● Question

● Prerequisites

REFCLK : Input(HCSL) x1, Output (HCSL) x2

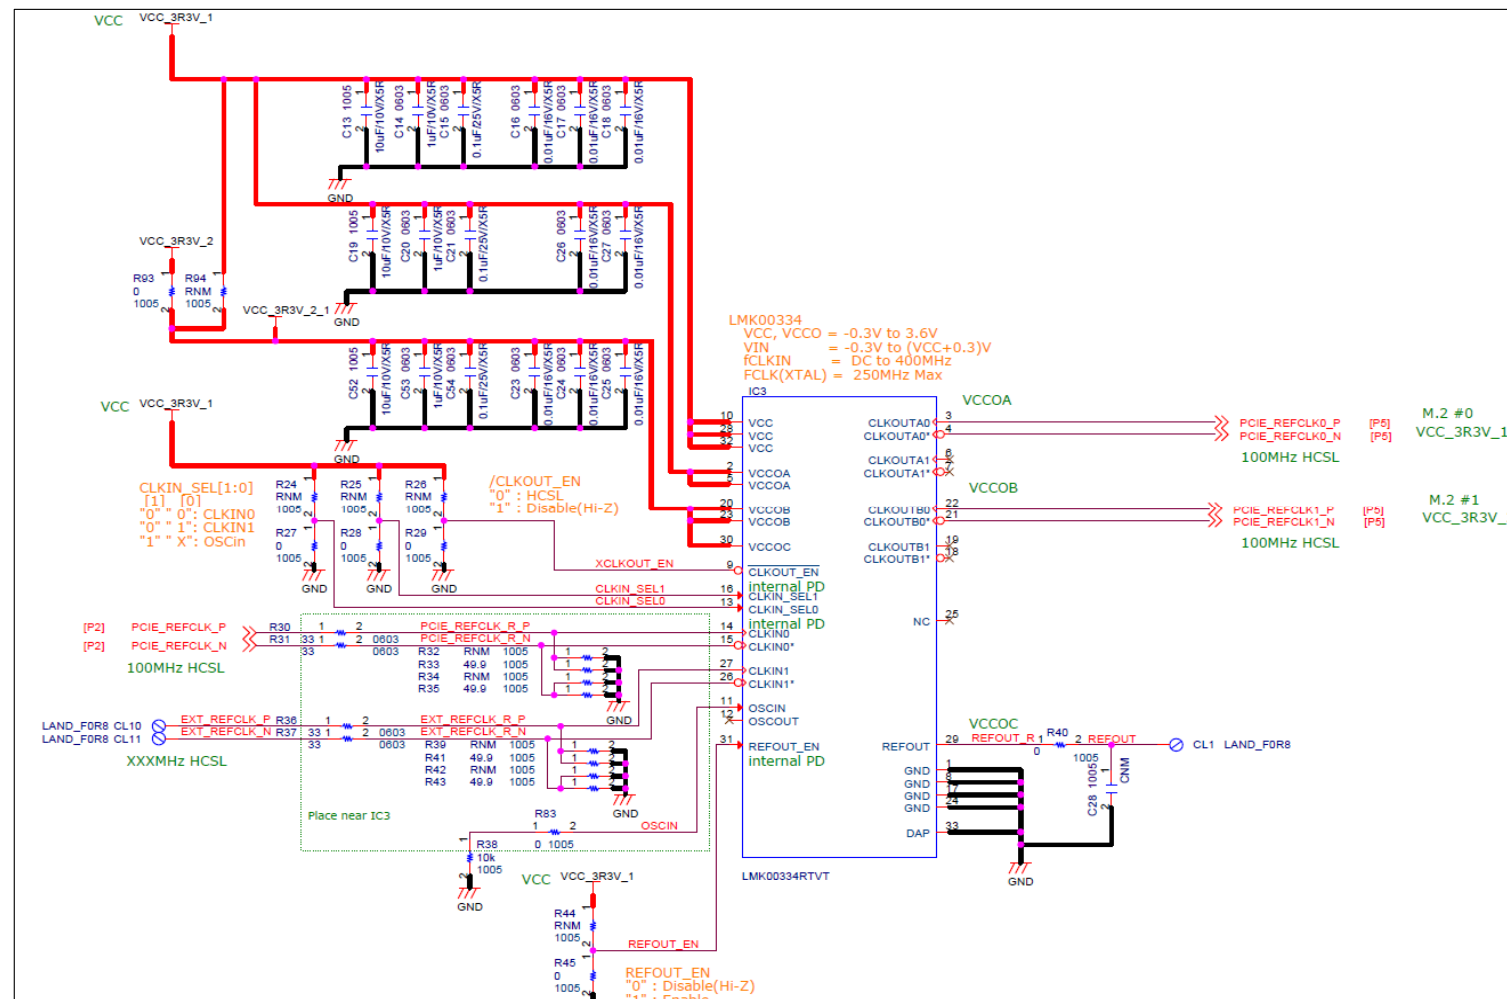
1. Is there a difference in output behavior between using the output separately for bankA and bankB and using it together for bankA?
 2. Is there any problem with the input processing of CLKIN [0/1] and OSCIN?
 3. Is there any problem with the power connection of VCC, VCCOA, VCCOB, VCCOC?
 4. Do you have any concerns by looking at the schematic?
- * For details, refer to the circuit diagram and block diagram.
